SERVICE BULLETIN

APPLICABILITY: 2010-14MY Legacy and Outback Models
SUBJECT: Design Change to Retaining Clip for Front ABS Wheel Speed Sensor

NUMBER: 06-49-15R
DATE: 05/29/15
REVISED: 02/08/16

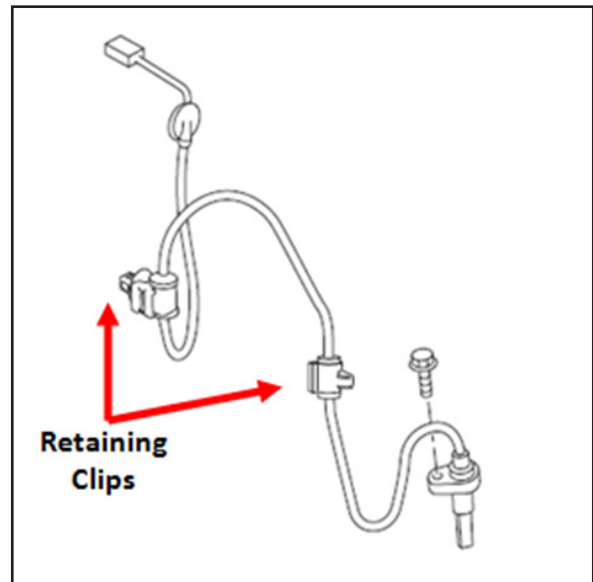
In response to isolated reports of cracked or broken ABS wheel speed sensor harness retaining clips caused by reaction with acids used in some wheel cleaners, the clip material has been changed to polypropylene (PPO).

The new retaining clips can be identified by the molded in >PP< as shown in the photo below. There are 2 clips on each sensor harness.

IMPORTANT: In the event a cracked or broken sensor harness retaining clip is identified, **all 4** of the clips (2 per side) **MUST** be replaced.

CAREFULLY remove the retaining clips from the sensor harness and always install the replacement clips back in the same position as the originals.
